January 4, 2024

Salisbury Inland Wetlands & Watercourses Commission  
Salisbury Town Hall  
27 Main Street  
P.O. Box 548  
Salisbury, CT 06068

**Re: Dresser Woods, Railroad Street, Salisbury**  
**Project 4010271.23137**

We are in receipt of peer review comments from Thomas D. Grimaldi dated December 22, 2023. Below we cite the original comment and our responses. The original comments are in italics.

DRAIN OUTLET PROTECTION  
NOT TO SCALE

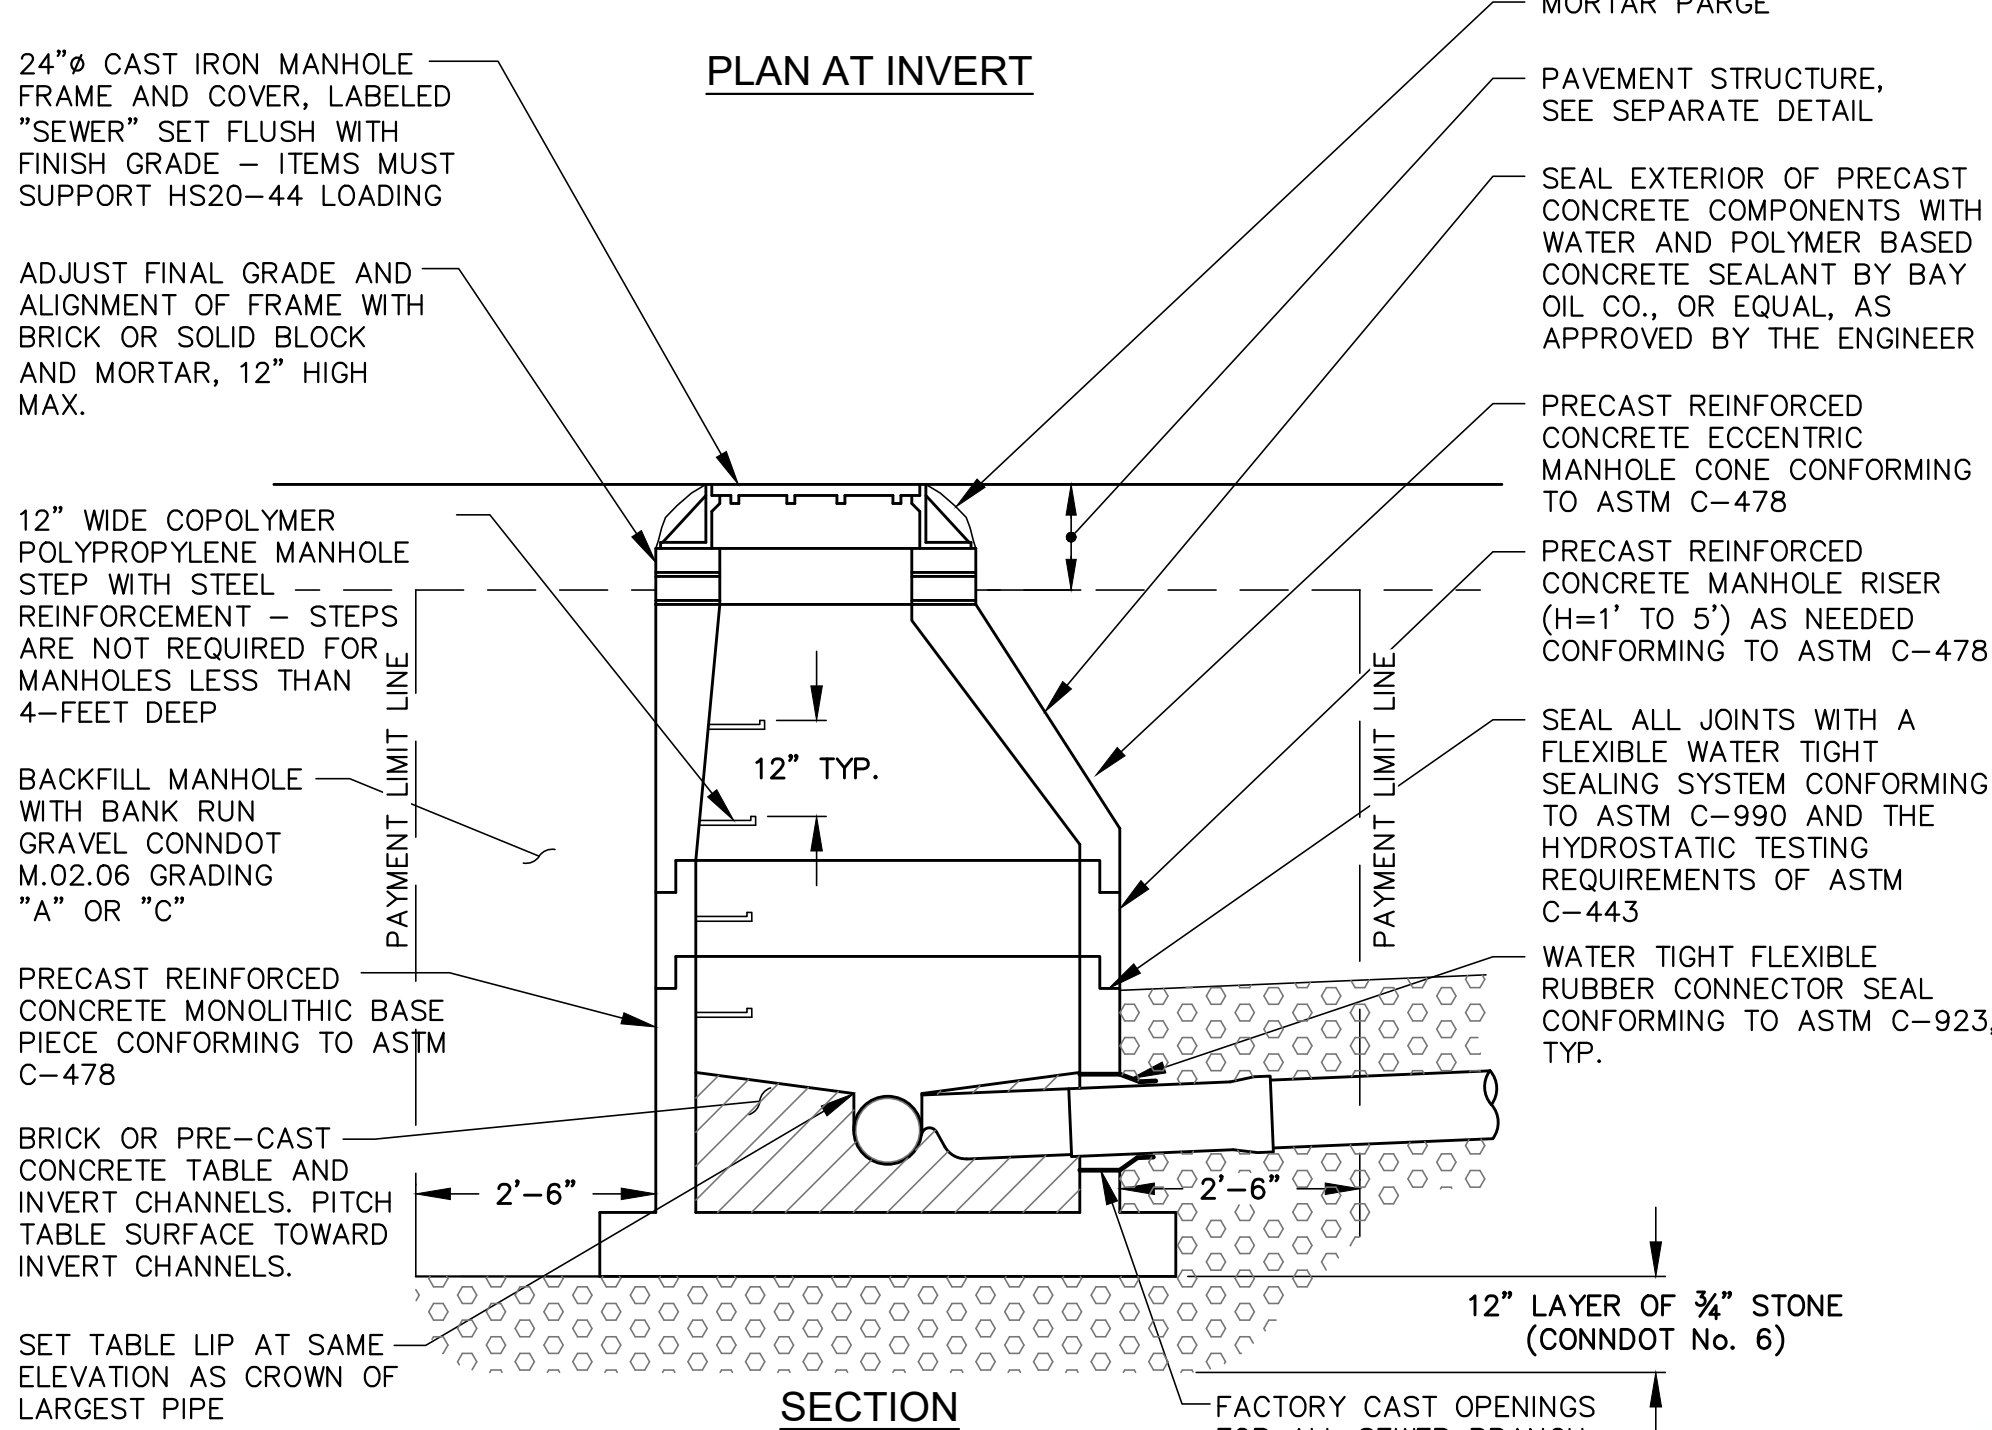
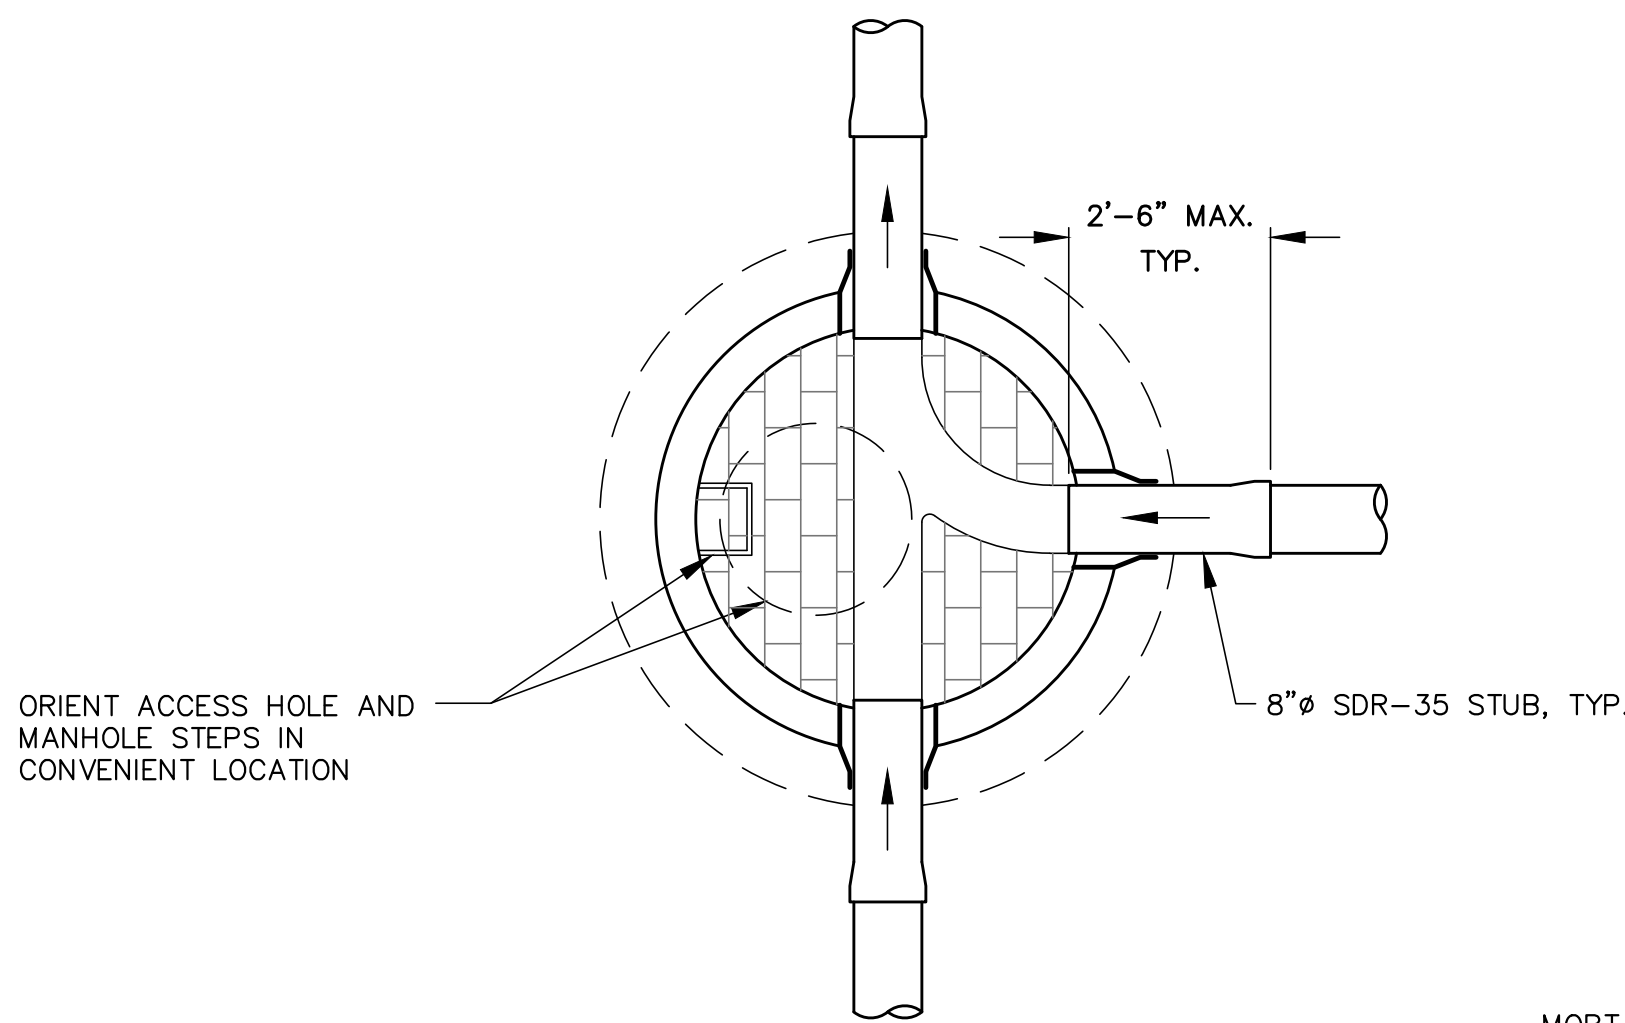
1. *Provide outlet protection for all point source discharges.*

Outlet protection has been provided.

BITUMINOUS CONCRETE PAVEMENT, CURB, AND SIDEWALK  
NOT TO SCALE

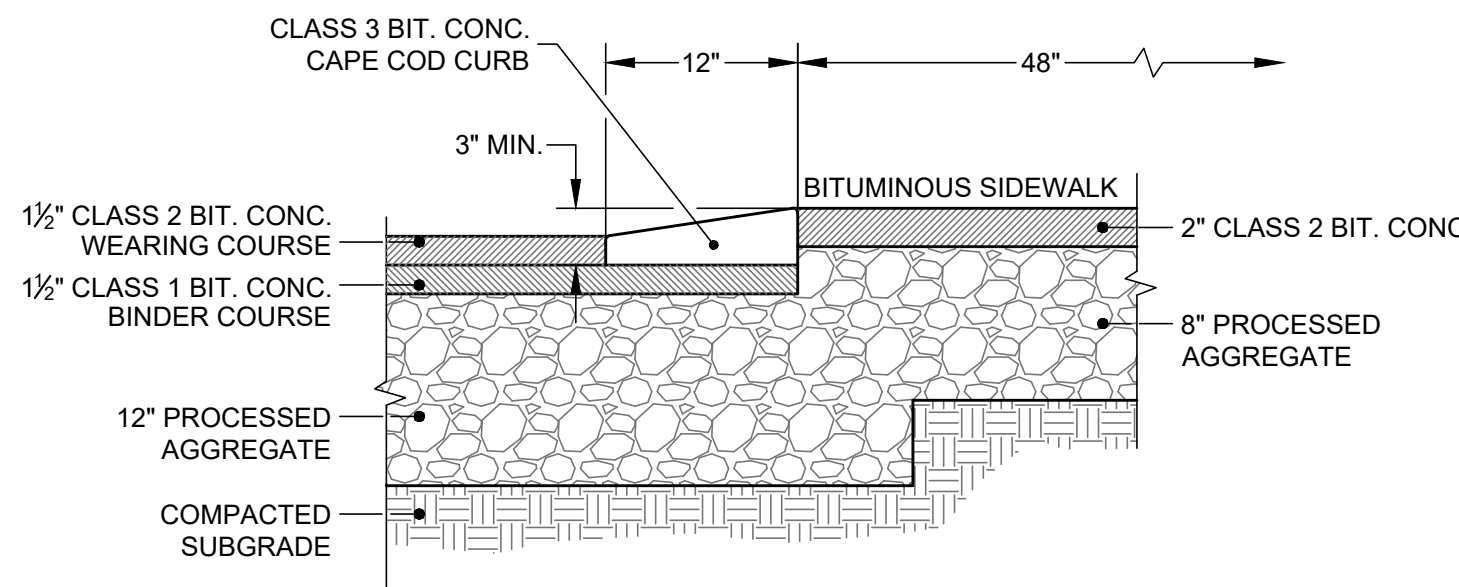
8. *Bituminous Concrete Pavement Detail conflicts with the Bituminous Concrete Pavement, Curb, and Sidewalk Detail with regard to depths and make-up for base/subbase material.*

The details have been revised as requested. See Sheet 09.

SECTION THROUGH STORM WATER SYSTEM (PRETX, FOCAL POINT, R-TANK)  
NOT TO SCALE

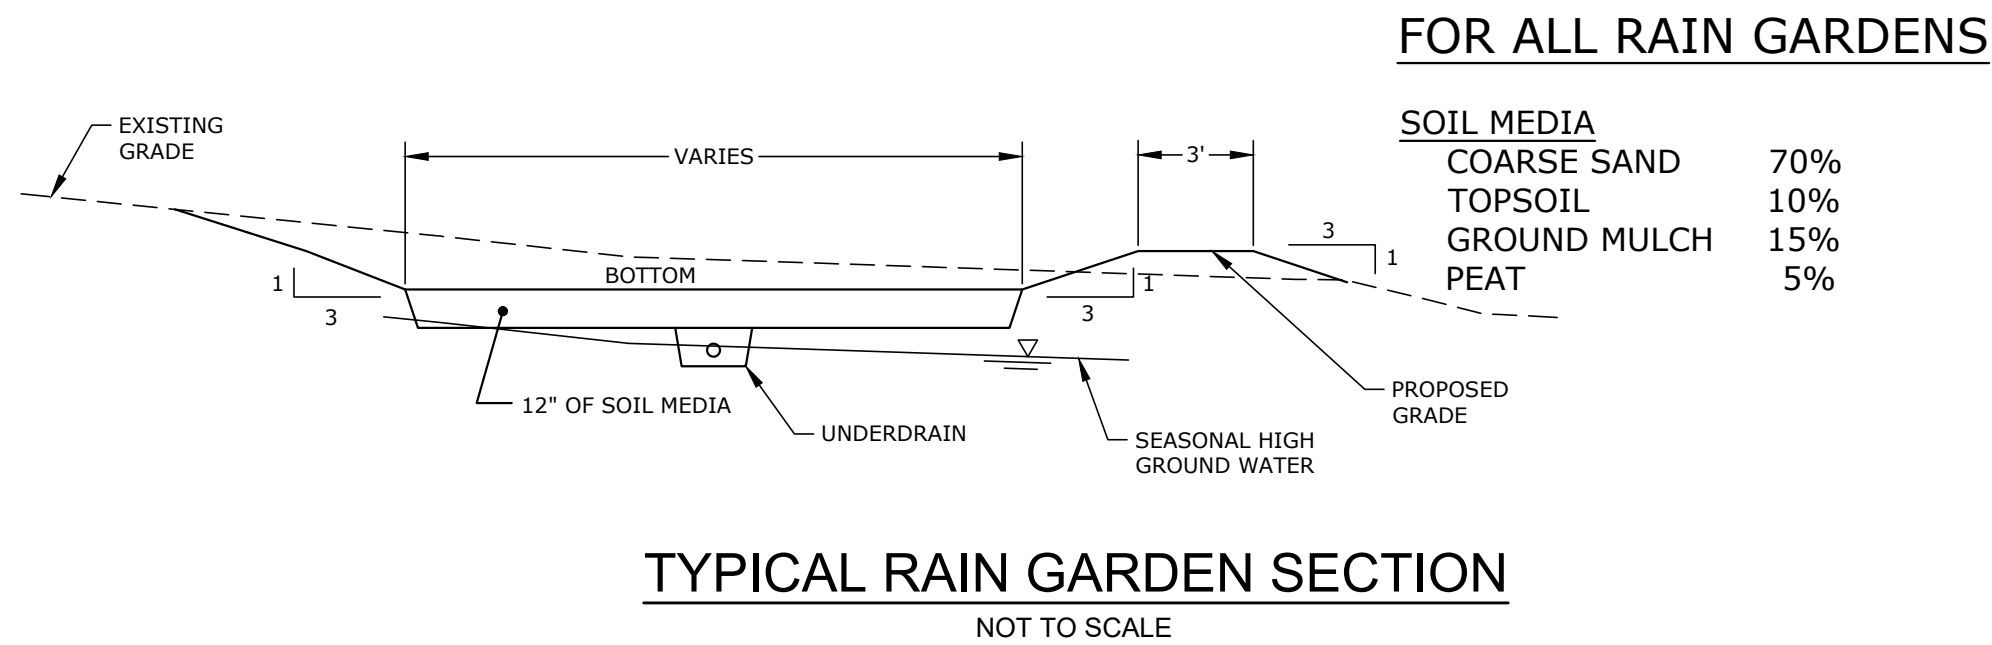
1. *Provide a detail of the R-Tank Subsurface Detention System.*

2. *Provide a detail for the Focal Point Treatment System.*

3. *Provide a detail for the PRETX Light drainage structure. Include flowlines for structure.*

A separate detail package for the Focal Point, Pretx, and R-Tank has been provided.
